Re: Application for Approval of the Long Lake South Project

LONG LAKE SOUTH PROJECT

Environmental
Impact Assessment (EIA)

Additional Supplemental Information

Figure 7-1 Bottom Water Pressure Map

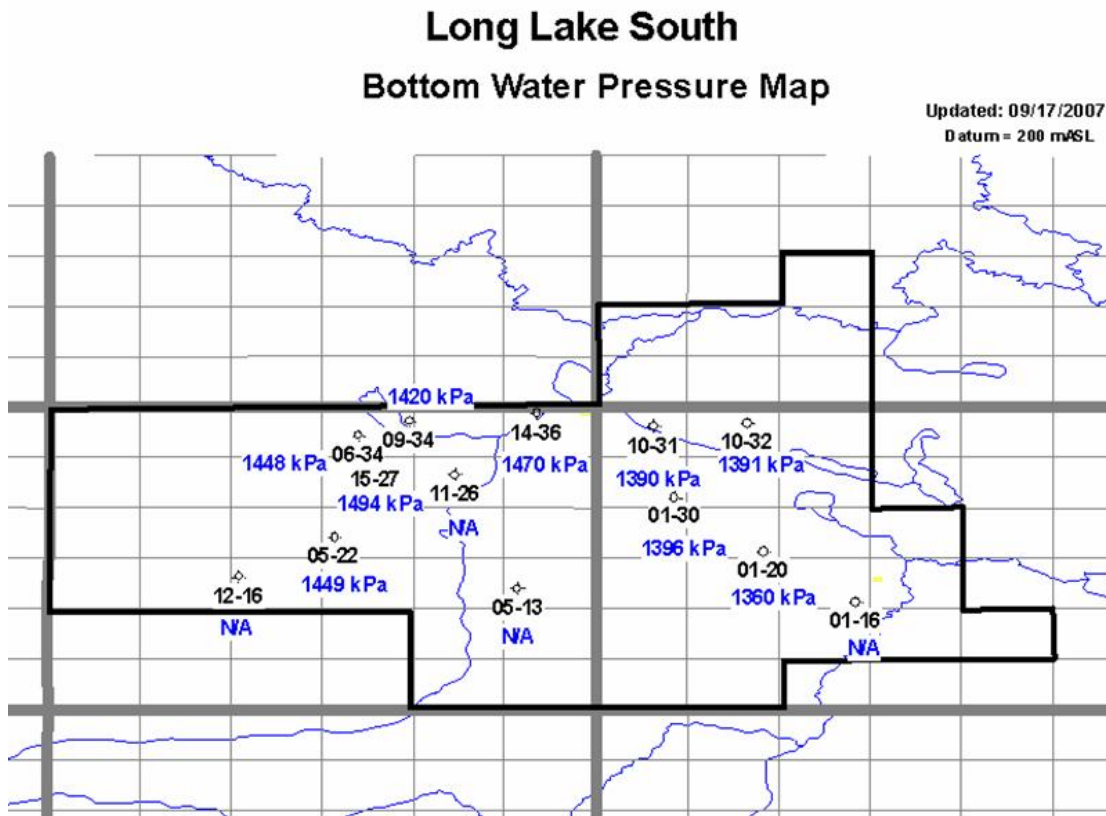
7.	<p>SIR Response #5:</p> <p>Given the low pressure of the gas cap at 460 kPa and the higher bottom water pressure of ~ 2200 kPa; how does Nexen plan to successfully exploit the resources in the reservoir? What analogy does it have to draw upon since no modelling with these conditions has been performed? Provide a detailed explanation including all supporting analysis and data on how the resources within these areas will be recovered in a manner that will maximize resource recovery.</p>
----	--

With regard to bottom water, the Partners made the following statement in Section 1.1.2 of LLS Project Update (Supplemental Information, August 2007): *"In order to minimize the influence of bottom water on SAGD performance, a minimum standoff of 5 m is imposed between the producer well and the bitumen/basal water contact. In areas where no bottom water is present, the producer well is placed as low as possible."* This minimum standoff should essentially isolate bottom water from SAGD steam chambers. In addition to standoffs, the Partners have also committed to reduced well length and spacing to 650 m and 75 m, respectively, which should allow for more flexibility in placing well pairs. Shorter wells will further enhance even steam distribution and production well subcool control. If matching pressure is deemed necessary, production intake pressure will be controlled at or slightly above the bottom water pressure, which would eliminate any potential water influx from bottom water or significant steam loss into bottom water. Nexen is confident that the impact of bottom water on SAGD in LLS can be effectively eliminated or minimized. For reference, the average bottom water pressures measured across the LLS Project are 1456 kPa and 1384 kPa respectively, from west to east (Bottom Water Pressure Map, Figure 7-1). The average measured bottom water pressure from all available piezometres in LLS is approximately 1420 kPa.

PROJECT		Nexen/OPTI Long Lake South Project	
TITLE		Baseline Scenario 98 th Percentile 24-h PM _{2.5} Concentration	
DRAWN	NS	22/06/2007	SIR Figure 16-1
CHECKED	SBB	22/06/2007	
REVIEWED	KEP	24/06/2007	
PROJECT	W06-1092A

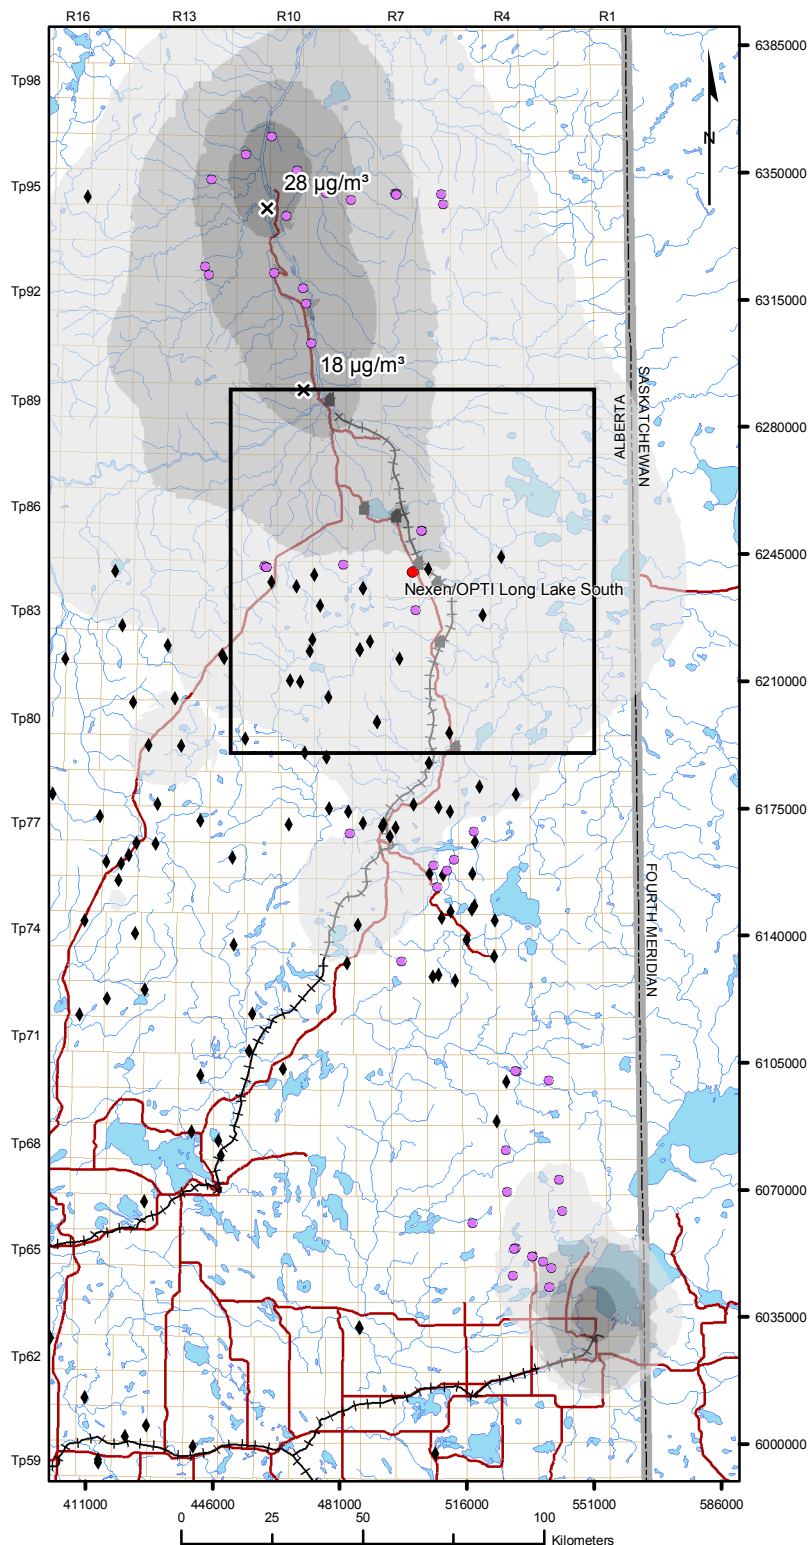
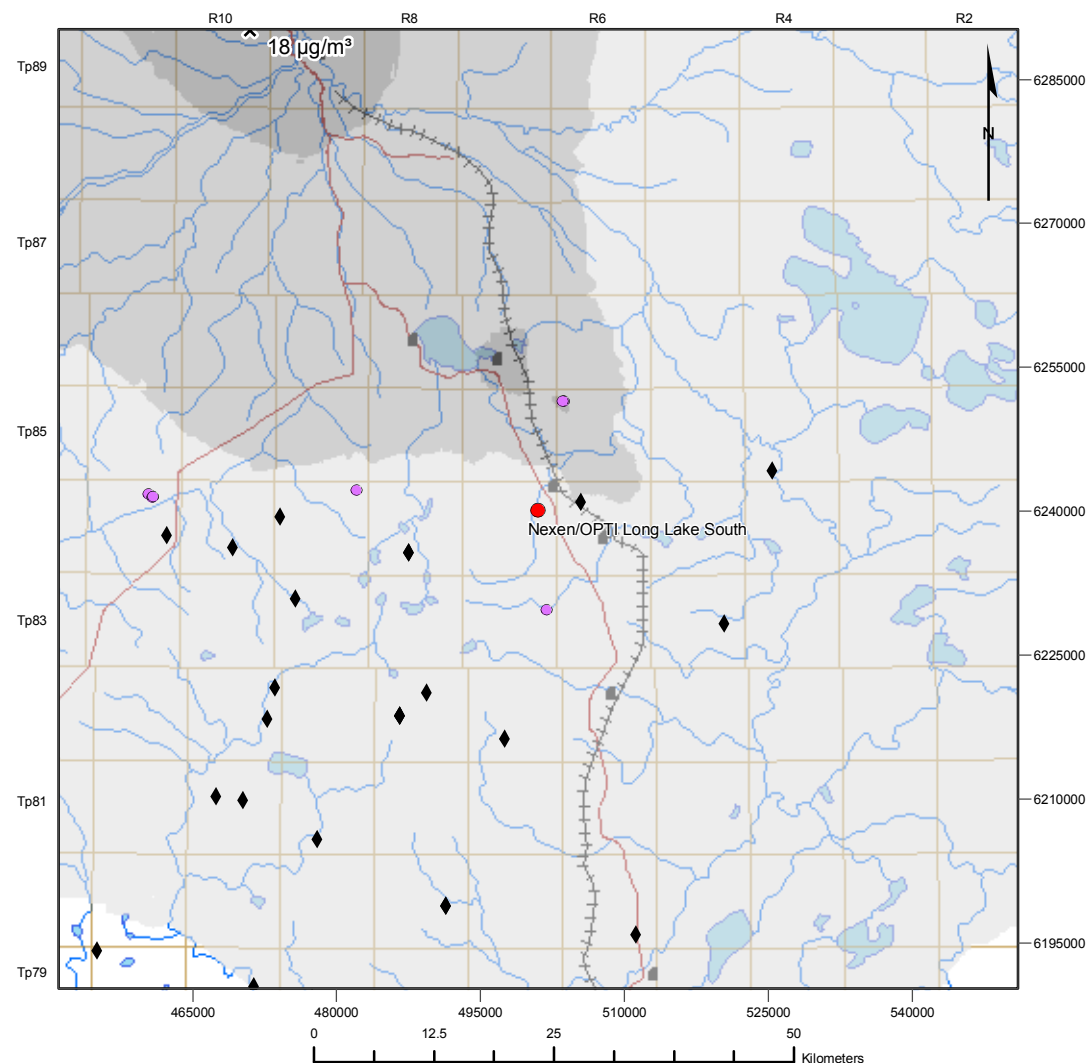
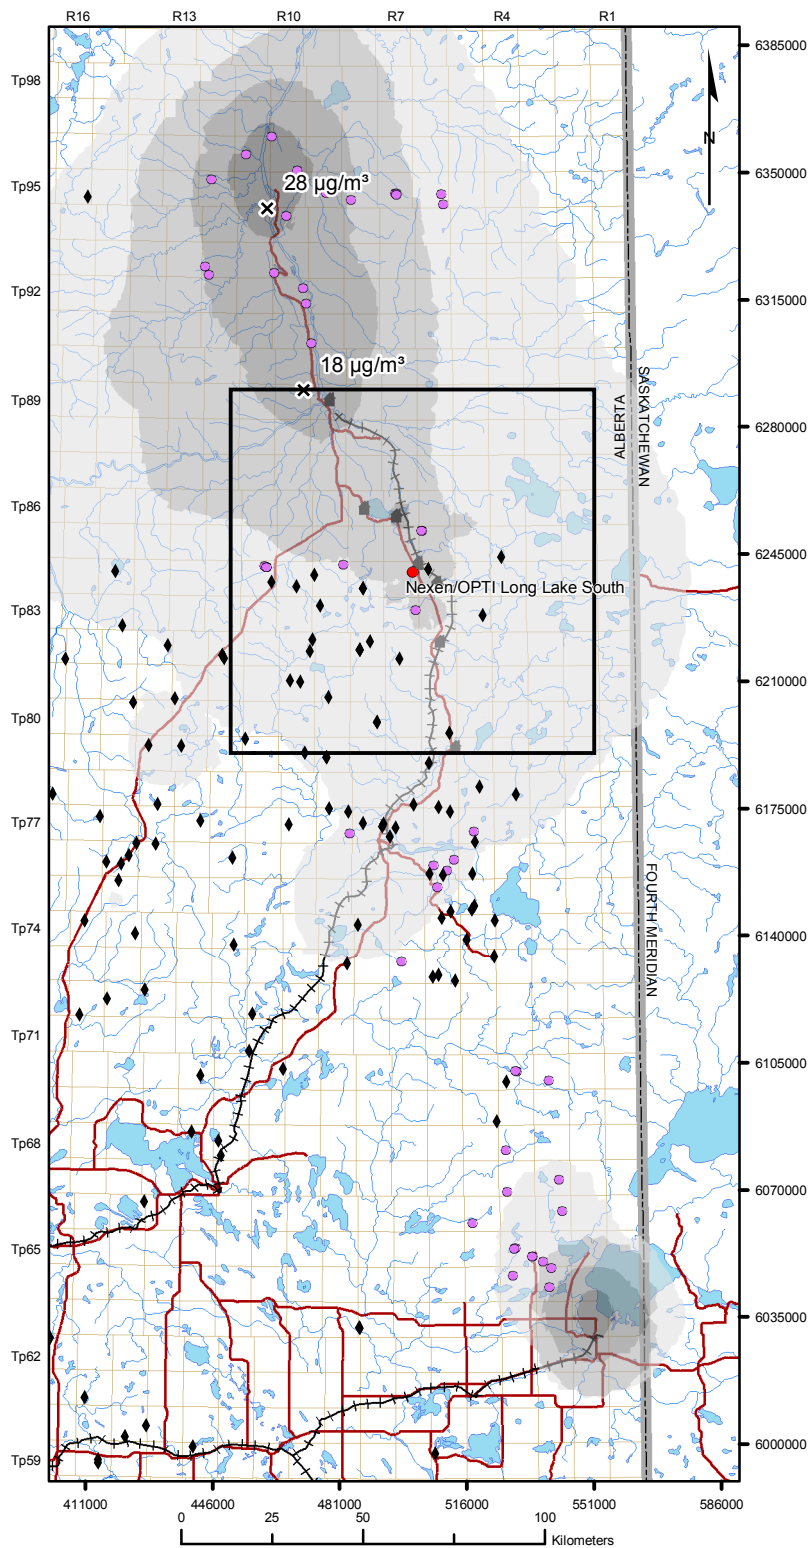
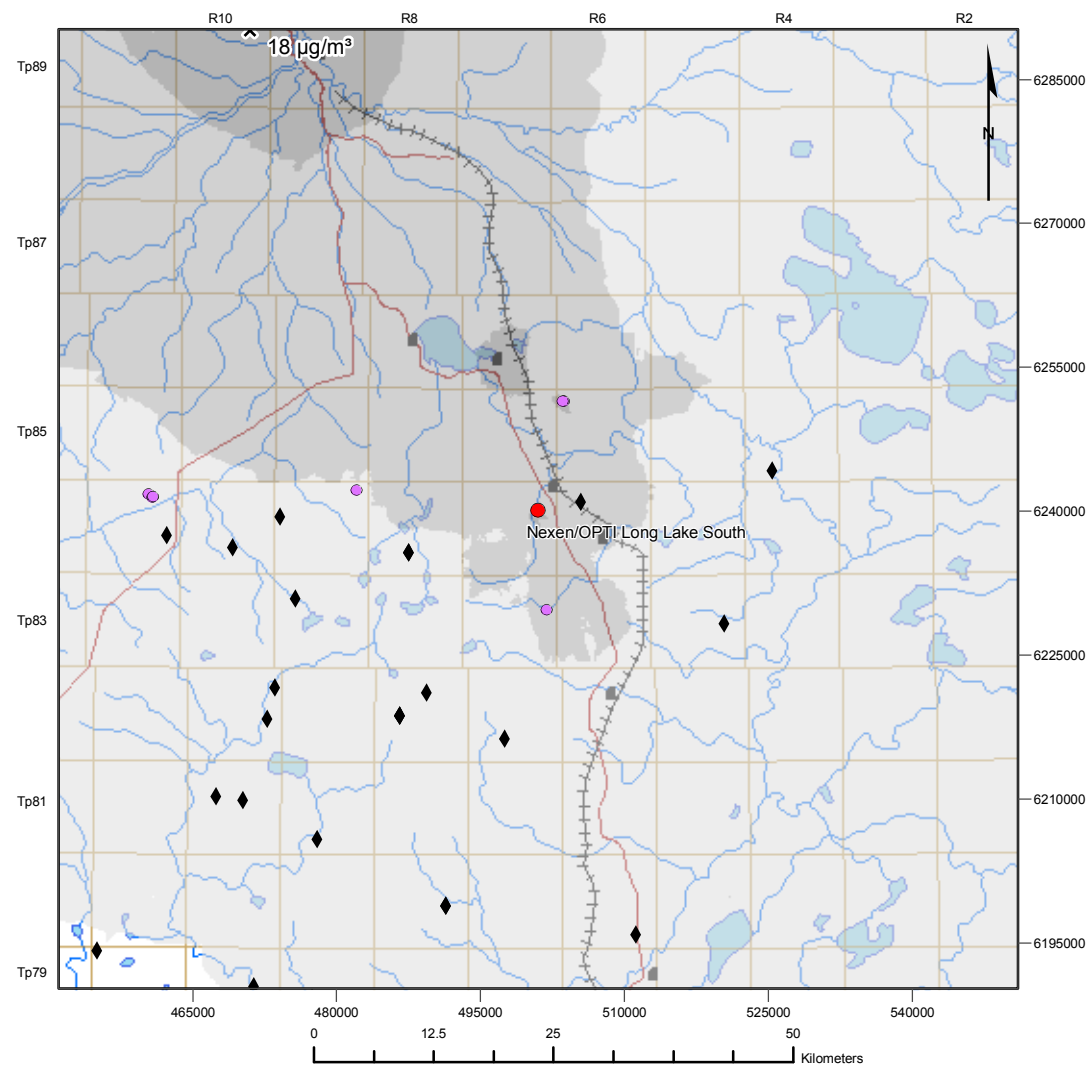
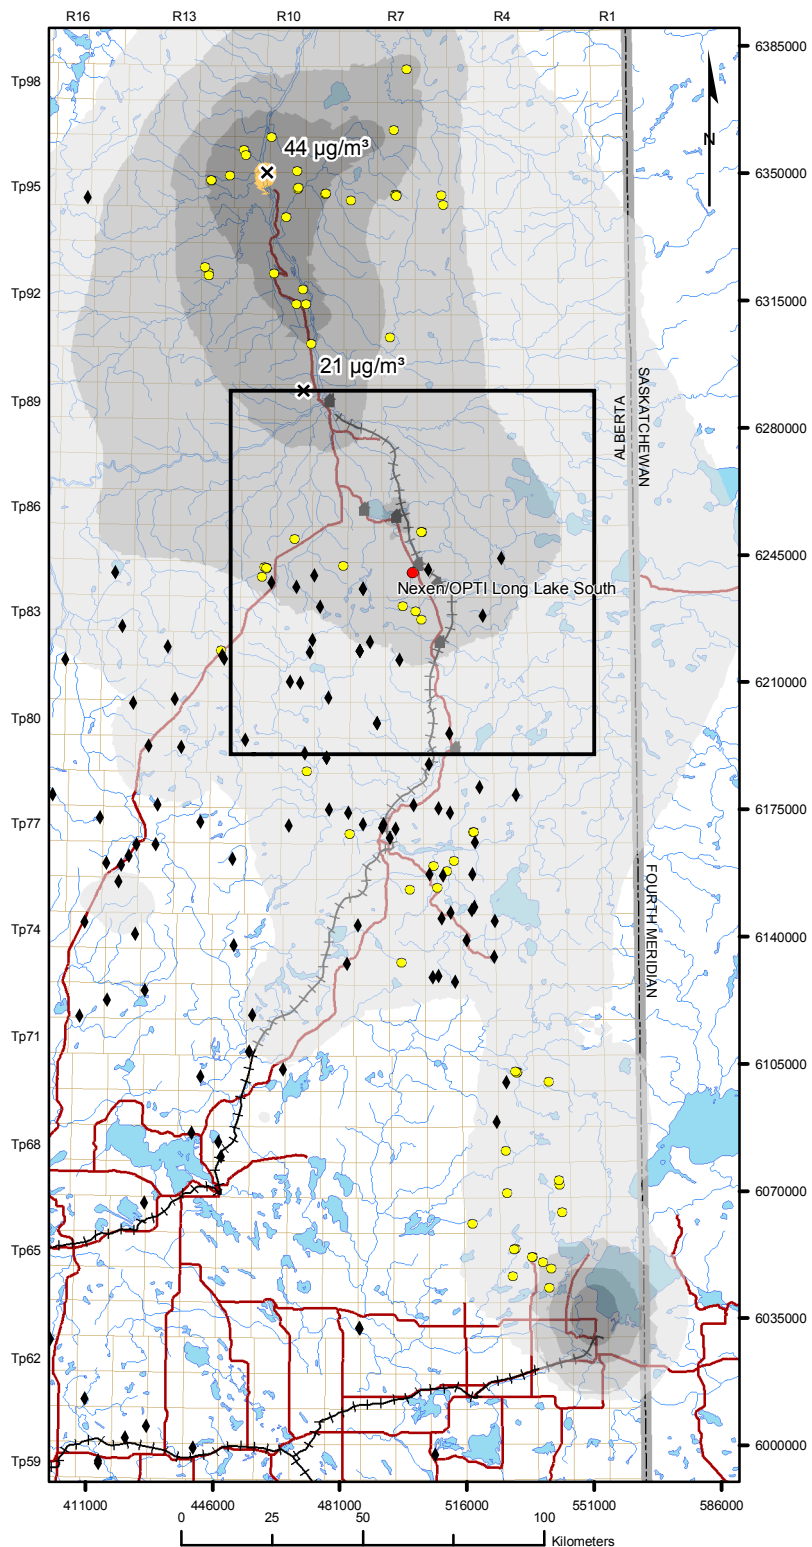
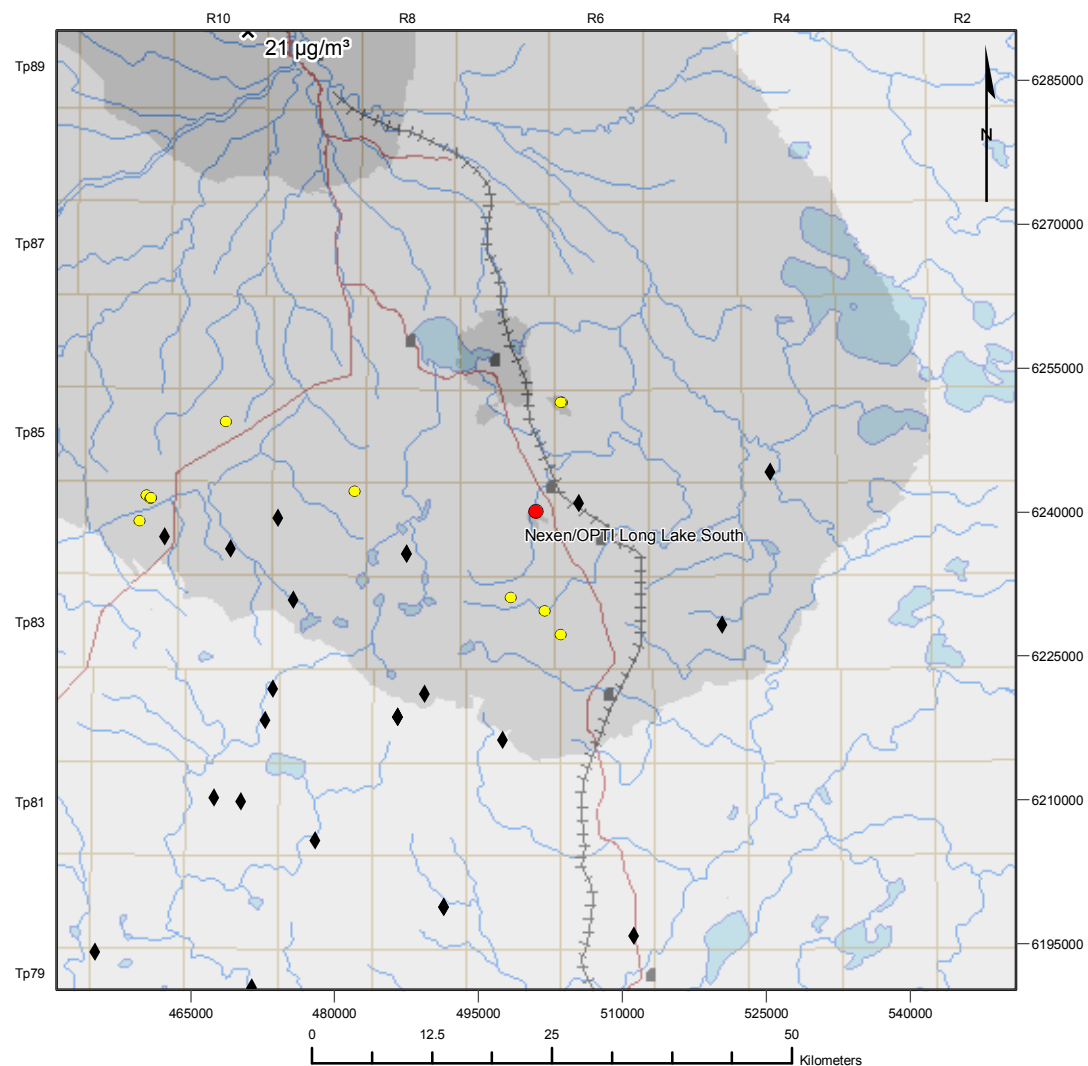
16.	<p>Supplemental Information, Part 2, Section 2.3 Air, SIR response #75, Figures 75-7 (Page 86) and 75-23 (Page 102)</p> <p>When comparing the baseline, application and cumulative 24-hour $PM_{2.5}$ concentration scenarios two anomalies occur:</p> <ol style="list-style-type: none">I. The first is to the NE of the LLS site where the baseline scenario indicates a contour range of 8-15 ug/m^3. On the application scenario the contour area decreases in size at that location. On the cumulative scenario the contour decreases further to indicate an area of 0 ug/m^3.II. The second is to the S/SW of the LLS site where the baseline scenario indicates a contour range of 0 ug/m^3. On the application scenario the 0 ug/m^3 contour area increases in size at that location implying a decrease in $PM_{2.5}$ concentrations at that location. Little change is noted on the cumulative scenario implying another possible decrease in $PM_{2.5}$ concentrations. <p>Intuitively one would expect the concentrations to increase as sources are added to the dispersion model. Explain these differences.</p>

The mathematical computation used to interpolate the data used to create Figures 75-7, 75-15, and 75-23 (SIR Aug/07 [AENV Response 75](#)) was incorrect and not consistent with other figures used in the report. These figures have been corrected (as Figures 16-1, 16-2 and 16-3 respectively) and there are no longer decreases in the contours. The data used in the HHRA are discrete receptors, do not rely on the mathematical interpolations, and as such have not changed.
